**SUPPLEMENTAL ENVIRONMENTAL IMPACT STATEMENT /
SUBSEQUENT ENVIRONMENTAL IMPACT REPORT**

Los Angeles Rail Rapid Transit Project Metro Rail

**U.S. DEPARTMENT OF TRANSPORTATION
URBAN MASS TRANSPORTATION ADMINISTRATION**

NOVEMBER 3, 1988

FIGURE 3-3

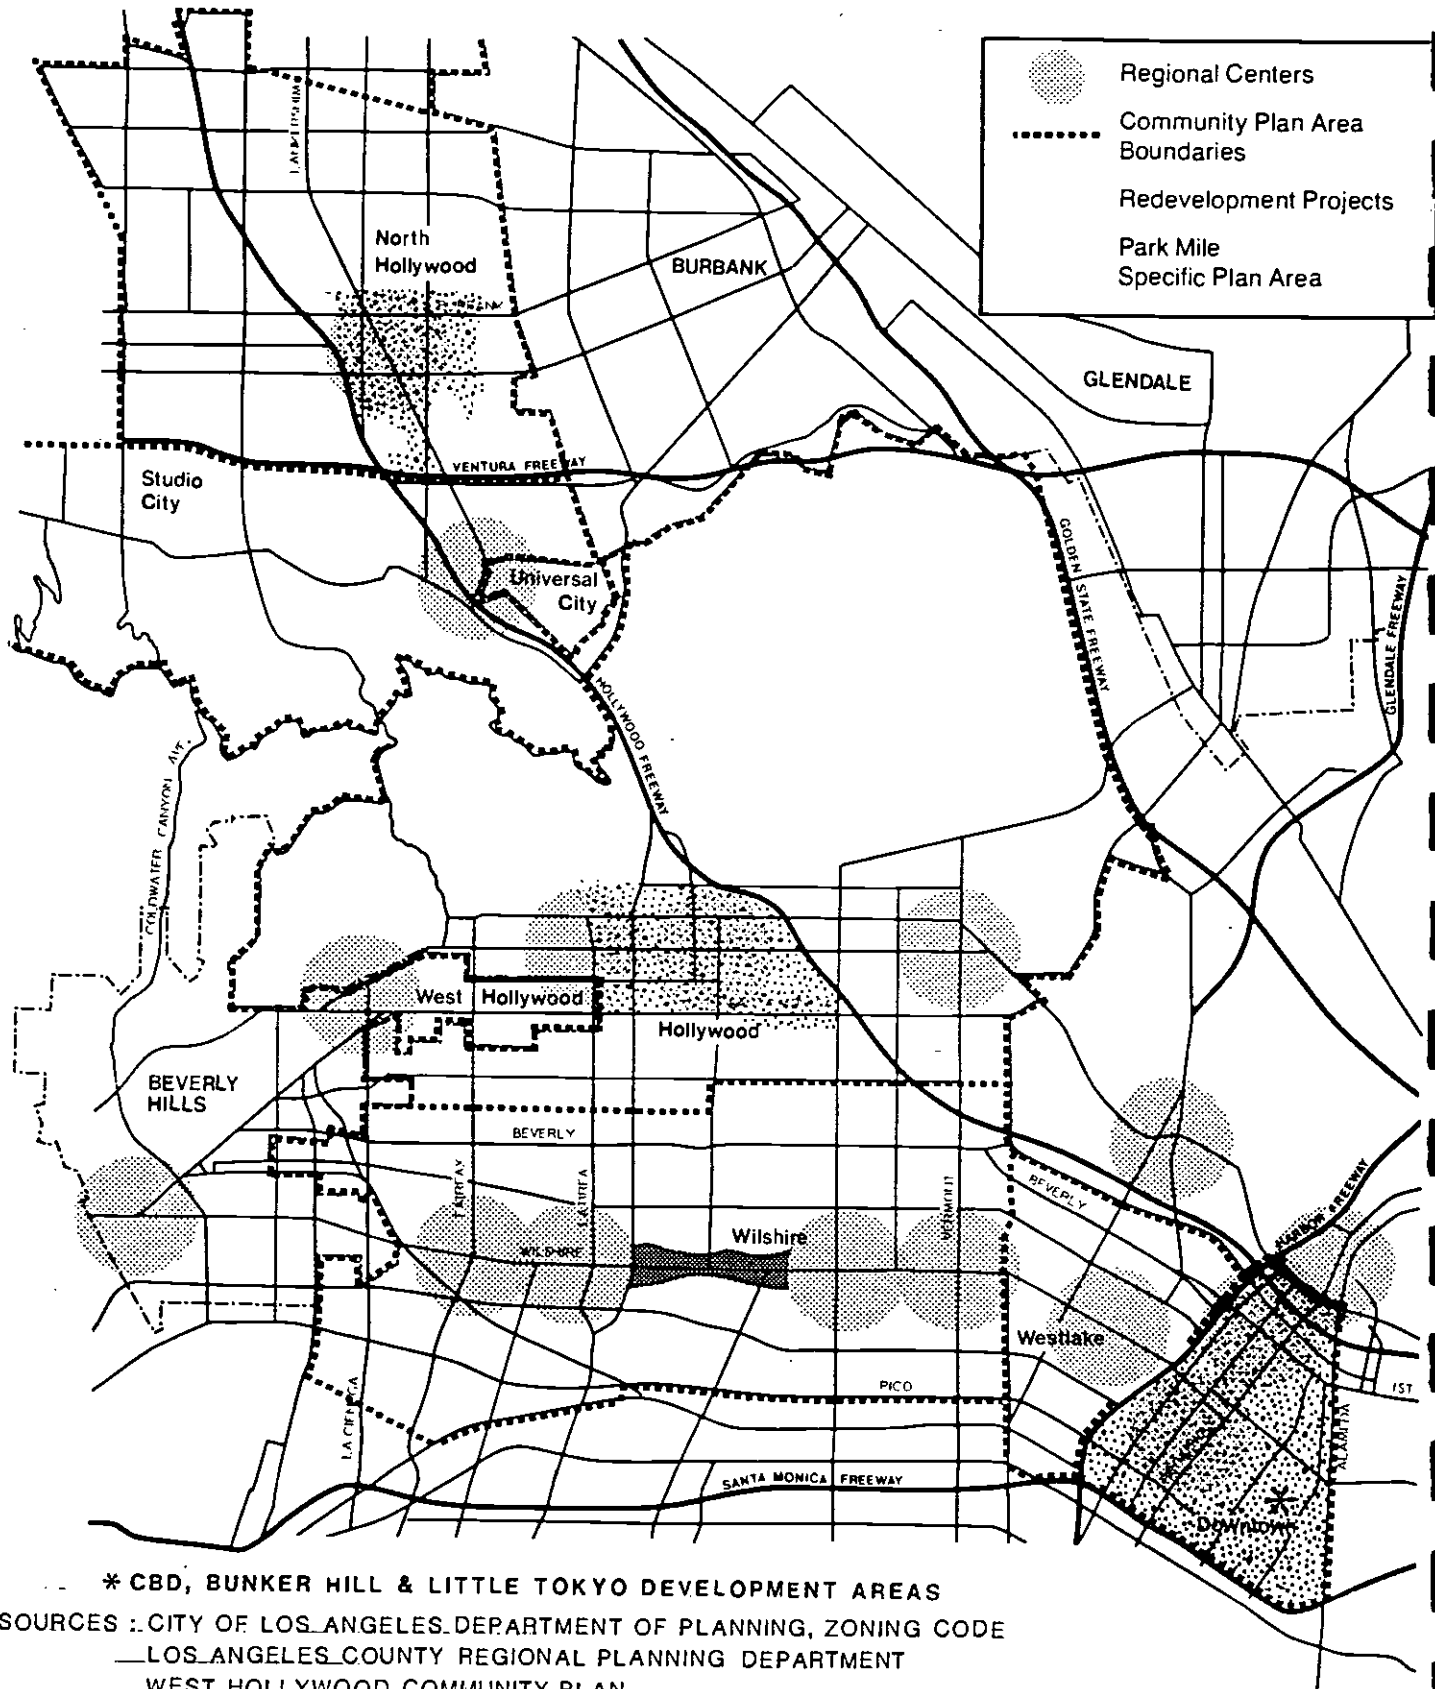
LU2 COMMENT: The CRA has three redevelopment areas in the downtown area: the Bunker Hill, Little Tokyo and CBD project areas. Figure 2-7 in the Draft SEIR should include the Little Tokyo CRA area. Other pending and adopted specific plans (Ventura Boulevard, Park La Brea, Koreatown and Westlake) could be added. (City of Los Angeles Planning Department)

ANSWER: Figure 2-7 (now Figure 3-3 of the Final SEIS/SEIR) also has been changed to include these areas in addition to the CBD Project area.

FIGURE 3-4

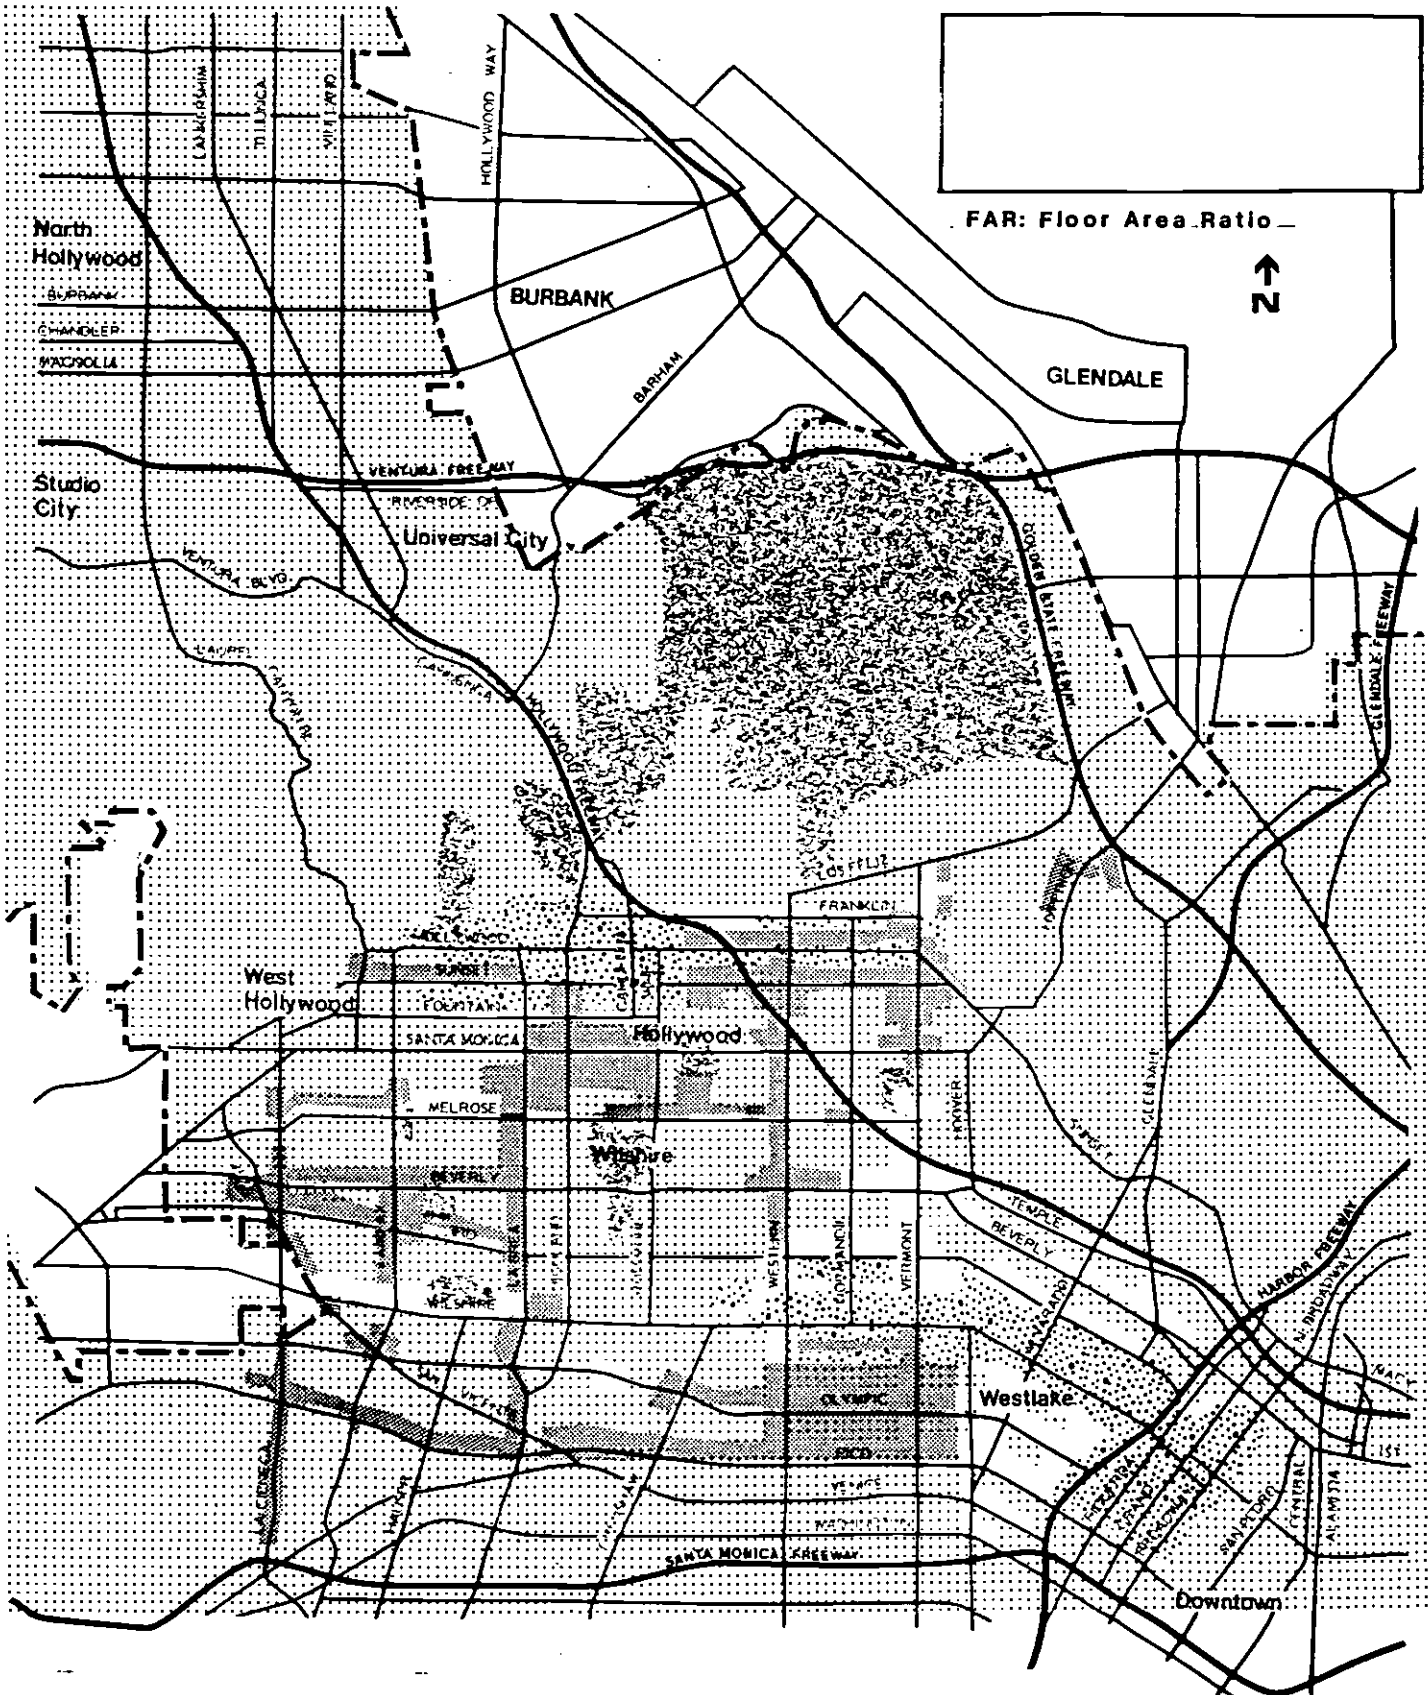
LU24 COMMENT: Regarding Figure 2-8 in the Draft SEIR, a review of current Community Plan-permitted densities and uses reveals that nearly all areas indicated for FAR 13:1 on the map permit only a 6:1 development level, while most shown for 10:1 and 6:1 allow levels only up to 3:1. Much of the area of the Santa Monica Mountains in Hollywood and Studio City shown as open space is designated for low density residential use. (City of Los Angeles Planning Department)

ANSWER: Figure 2-8 has been revised in the Final SEIS/SEIR using data from the City of Los Angeles Municipal Code (Zoning Code), the CBD Redevelopment Plan, the Wilshire District Plan, the Park Mile Specific Plan, the Westlake Community Plan and the North Hollywood Community Plan. It is noted that the correct FAR data used in the land use analysis was taken from Table 3-1 (page D-43 in the Appendix to the Draft SEIS/SEIR), and not from Figure 2-8.
